MEMORANDUM

TO: Historic District Commission
City of Saugatuck

MEETING DATE: September 3, 2026

RE: Historic District Permit Application, 333/337 Culver Street

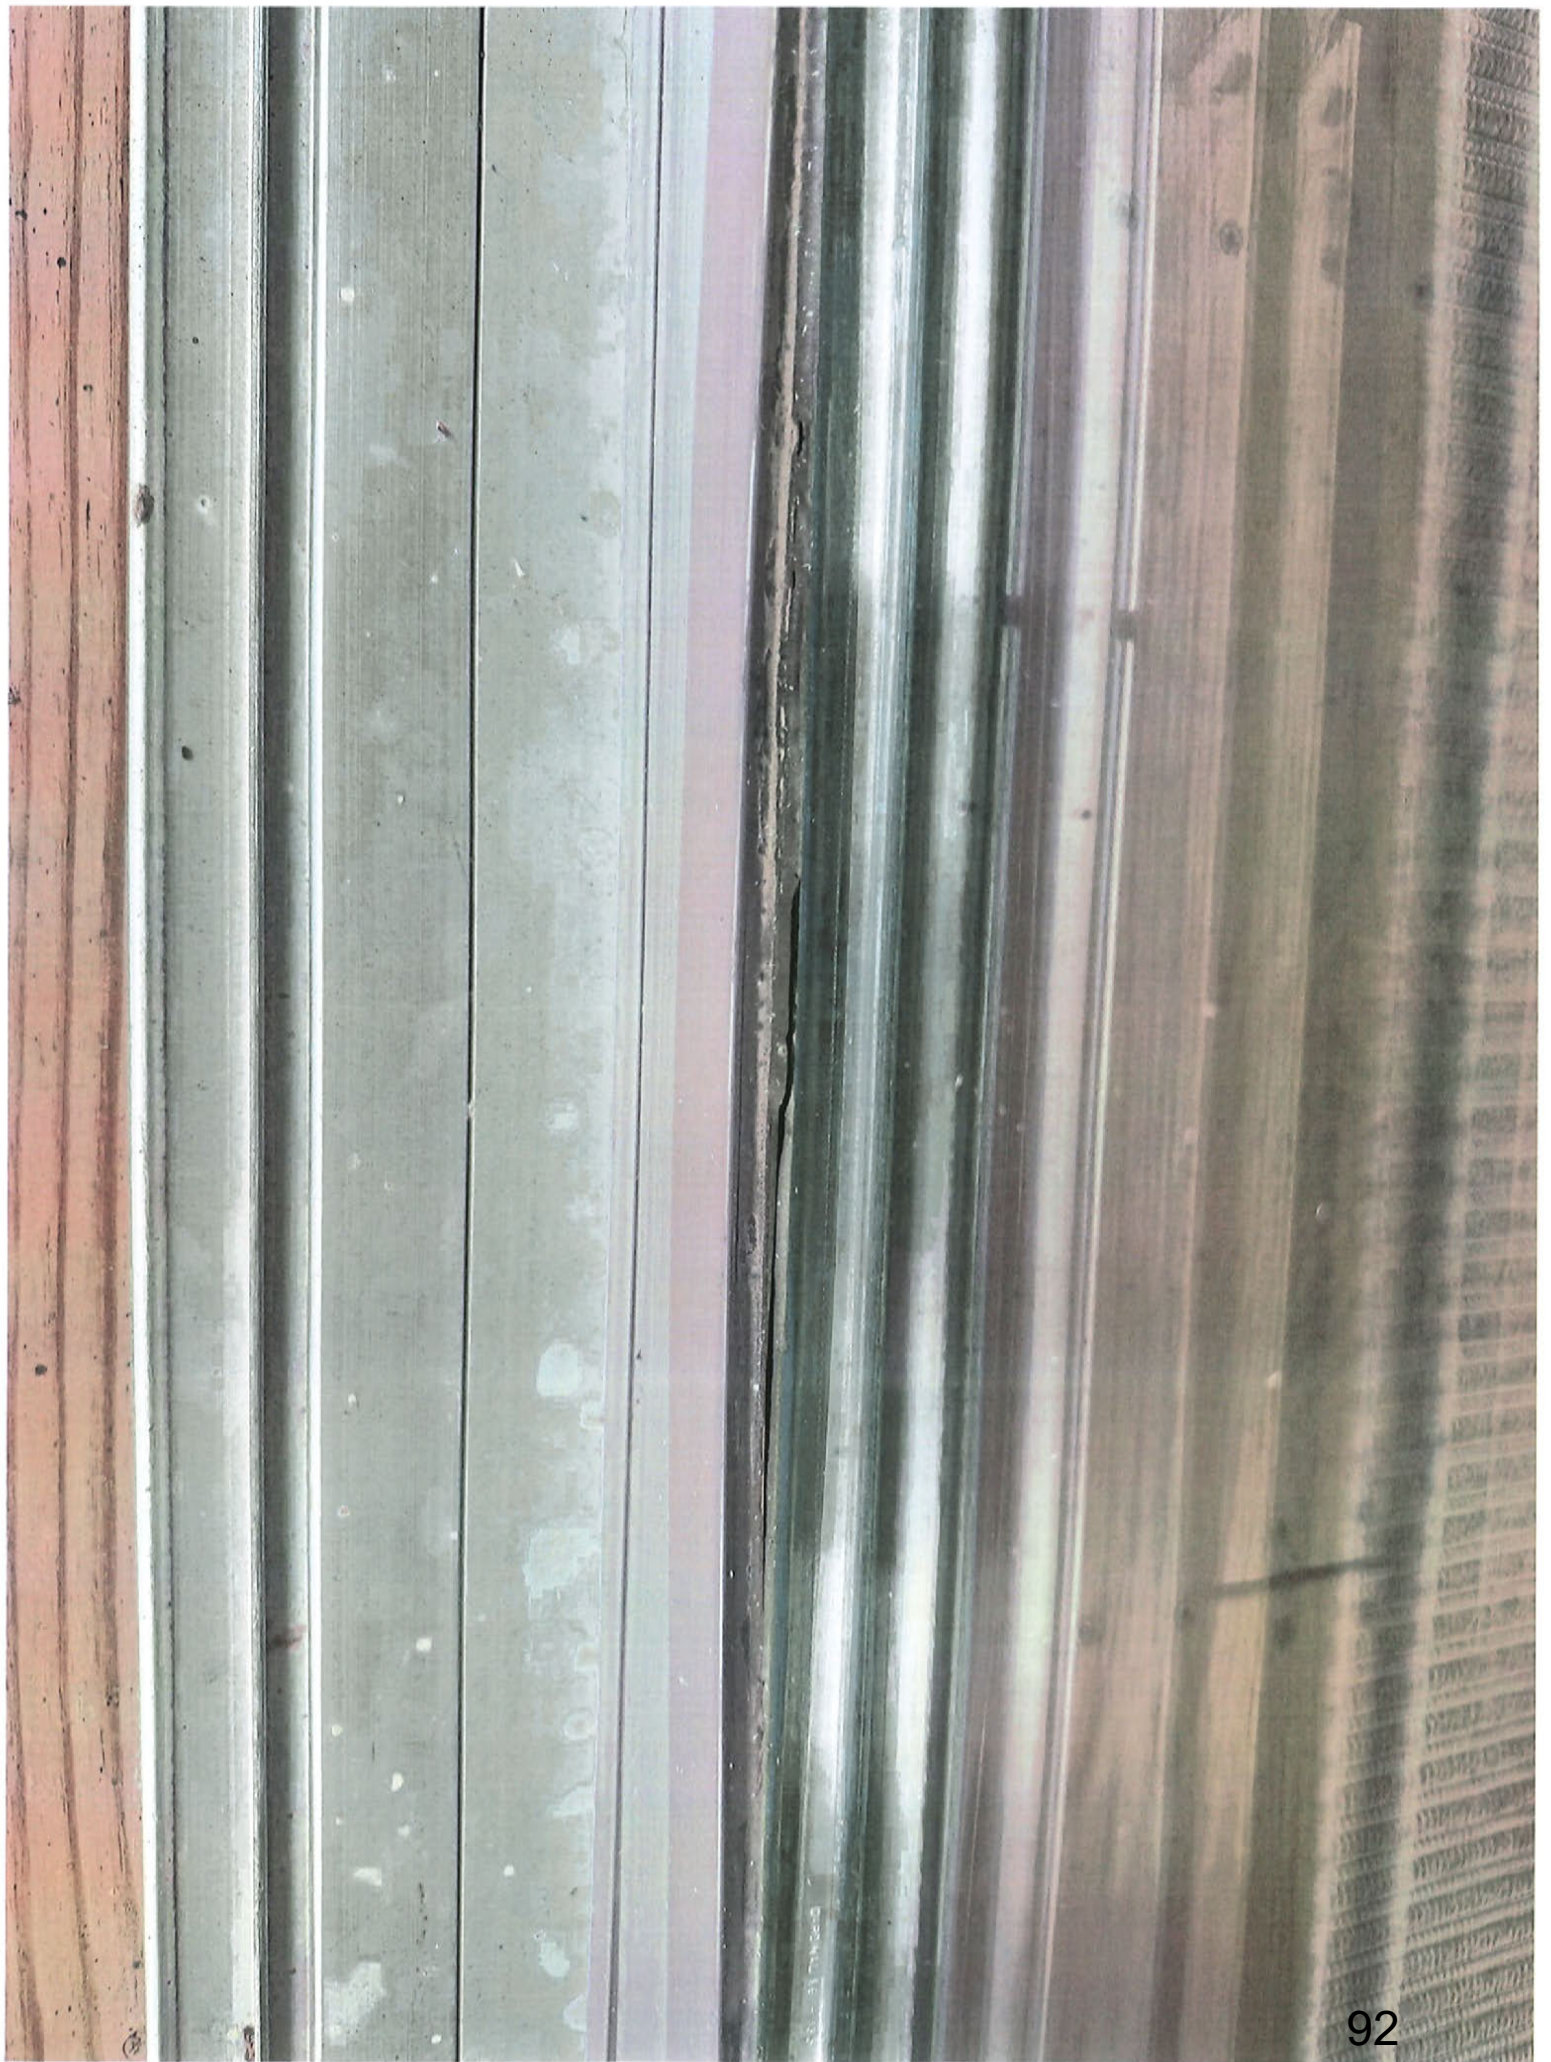
4 TRANSOMS

338 2 SLIDERS

337
SINGLE
SASH
